> AR# 53561: Design Advisory for Artix-7 FPGA GTP Transceivers: RX Reset Sequence Requirement for Production Silicon

### Design Advisory for Artix-7 FPGA GTP Transceivers: RX Reset Sequence Requirement for Production Silicon

AR# 53561	
Date	02/17/2017
Status	Active
Type	Design Advisory
Devices	• Artix-7

#### 1) GTRXRESET:

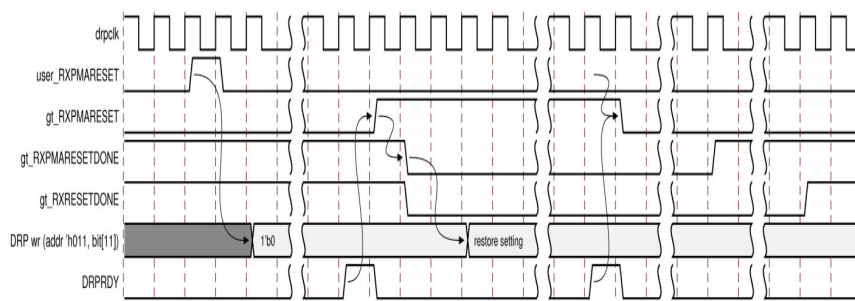
The following reset sequence must be followed when the user wants to perform GTRXRESET.

1. User triggers a reset request by asserting `user_GTRXRESET`.
2. Set and hold `gt_GTRXRESET` High. This will cause `gt_RXPMARESETDONE` to go Low.
3. Issue DRP write to the `GTPE2_CHANNEL` primitive, DRP address `9'h011`, and set bit[11] to `1'b0`.

4. In order to ensure only bit[11] of DRP address `9'h011` is modified, it is best to perform a read-modify-write function.
5. Upon DRP write completion and `user_GTRXRESET` detected as Low, set and hold `gt_GTRXRESET` Low. If `user_GTRXRESET` remains asserted upon completion of the DRP write, continue to assert `gt_GTRXRESET` until `user_GTRXRESET` is Low.

6. Wait for falling edge of `gt_RXPMARESETDONE`.
7. Issue DRP write to the `GTPE2_CHANNEL` primitive, DRP address `9'h011`, restoring the original setting for bit[11]. The completion of this DRP write must occur before `gt_RXPMARESETDONE` switches from Low to High. `gt_RXPMARESETDONE` will stay Low for a minimum of 0.66 us.

1. Make sure `gt_GTRXRESET` is output of a register.
2. Make sure `RXPMARESET_TIME` is set to `5'h3`. This should be the default setting.
3. The sequence above will only simulate properly if `SIM_GTRESET_SPEEDUP` is set to `FALSE`. If `SIM_GTRESET_SPEEDUP` is set to `TRUE`, the above sequence must be bypassed.

## 2) RXPMARESET:

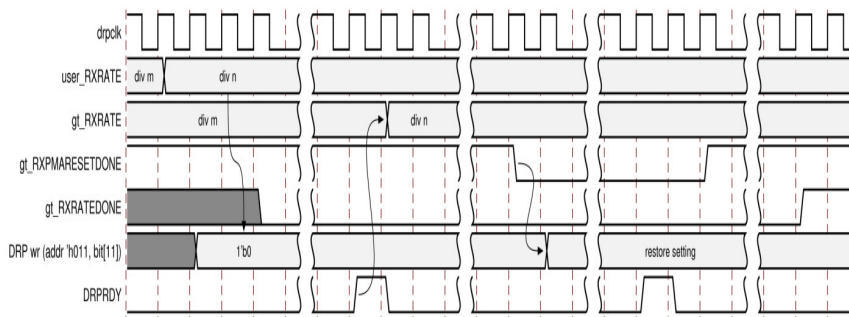
The following reset sequence must be followed when the user wants to perform `RXPMARESET`.

1. User triggers a `RXPMARESET` request by asserting `user_RXPMARESET`.
2. Issue DRP write to the `GTPE2_CHANNEL` primitive, `DRPADDR`

9h011, and set bit[11] to 1b0.

3. In order to ensure only bit[11] of DRPADDR 9h011 is modified, it is best to perform a read-modify-write function.
4. Upon DRP write completion, set and hold gt\_RXPMARESET High.
5. Wait for RXPMARESETDONE to go Low.
6. Issue DRP write to the GTPE2\_CHANNEL primitive, DRPADDR 9h011, restoring the original setting for bit[11].
7. Upon DRP write completion and user\_RXPMARESET detected as Low, set and hold gt\_RXPMARESET Low. If user\_RXPMARESET remains asserted upon completion of the DRP write, continue to assert gt\_RXPMARESET until user\_RXPMARESET is Low.

**Note:** Make sure gt\_RXPMARESET is output of a register.
